# APPLICATION

RE: PERCOLATION TEST RESULTS –  
A#528441  
8061 Browns Bridge Rd

PERCOLATION CERTIFICATION PLAN  
 LOT 1  
**RIVERVIEW**  
 FLAT NO. 10592  
 8061 BROWN'S BRIDGE ROAD  
 FIFTH ELECTION DISTRICT  
 HOWARD COUNTY, MARYLAND  
 SCALE: 1" = 40' SEPTEMBER, 2016

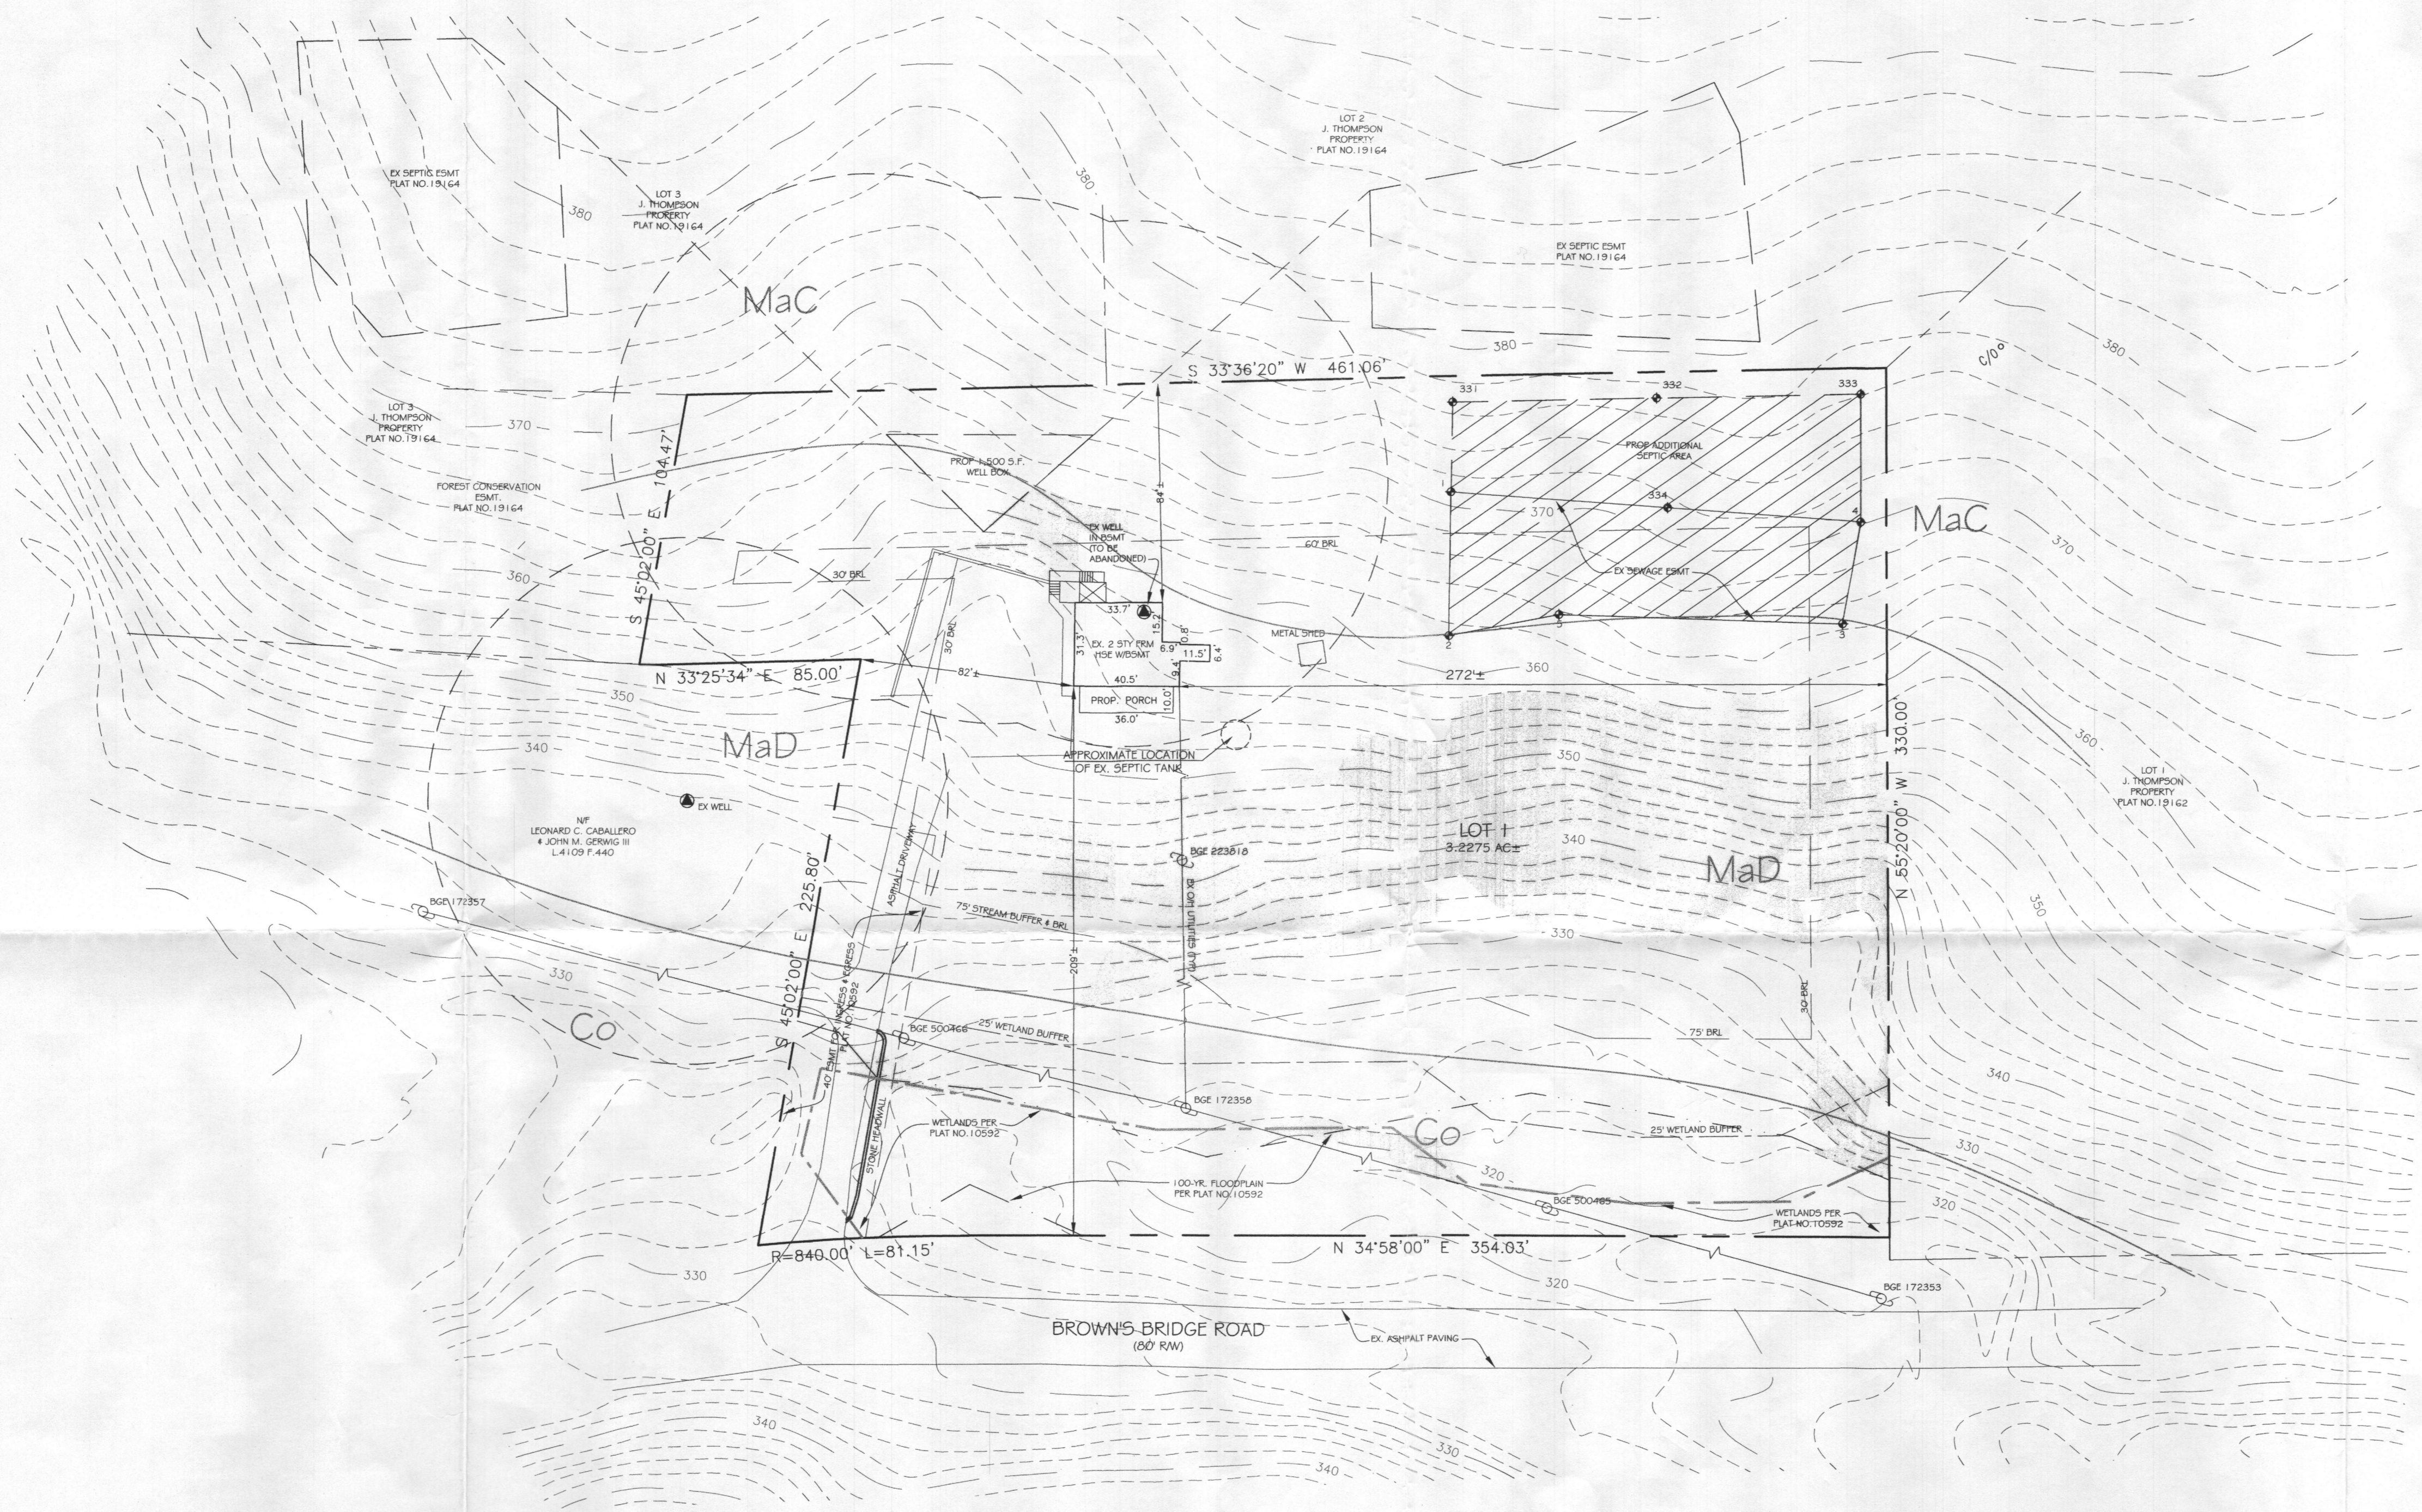
- 1.) Add to Note #14 or make it a separate note, The new septic system must be installed prior to Health Department signature of the building permit.
- 2.) Replace note #10 with, The new well must be drilled and the old well abandoned prior to building permit approval.
- 3.) Add purpose statement to the plan.

- 1.) Locate existing system and plot on perc cert plan. Please Note: This office has does not have record of the existing septic system. If existing system is undersized for the newly proposed floor plan showing 4 bedrooms, then a BAT plan will be required and system installed prior to BP approval.
- 2.) Change note #10 to state new well must be drilled and old well abandoned prior to BP approval
- 3.) Need a purpose statement on plan.

- 1.) The Sewage Disposal Area (SDA) must be located 25 feet away from all steep slopes greater than 25%. Adjust SDA accordingly.
- 2.) The two outer proposed well locations are down gradient of the SDA on neighboring lots. Use 1500 sq. ft. well box and place in area as shown on attachment.
- 3.) Adjust legend and symbol for well/ well box as needed.

Thanks for making the changes to the perc cert plan for 8061 Brown Bridge Road, but it still looks like a portion of the SDA is within 25 feet of the steep slopes. You may come in to revise the plan or submit new copies for review.

Mr. Schlueter thinks the existing system is located in front of the house. We would like to see this area bubbled-in and labeled approximate location of the existing septic system. Also, please add the following note to the perc cert plan:

- 1.) All existing septic components must be located and properly abandoned during the installation of the new system.

**Response 1:** SDA adjusted per comment.

**Response 2:** Proposed individual wells removed and well box added per comment.

**Response 3:** Proposed individual wells removed and well box added per comment.

**PURPOSE STATEMENT**  
 THE PURPOSE OF THIS PERCOLATION CERTIFICATION PLAN IS TO IDENTIFY THE PROPOSED ADDITIONAL SEPTIC AREA AND DESIGNATE THE WELL AND SEPTIC SYSTEM REQUIREMENTS FOR A BUILDING PERMIT.

- ANY CHANGES TO A PRIVATE SEPTIC AREA WILL REQUIRE A REVISED PERCOLATION CERTIFICATION PLAN.
  - ALL EXISTING COMPONENTS MUST BE LOCATED AND PROPERLY ABANDONED DURING THE INSTALLATION OF THE NEW SYSTEM. THE NEW SEPTIC SYSTEM MUST BE INSTALLED PRIOR TO HEALTH DEPARTMENT SIGNATURE OF THE BUILDING PERMIT.
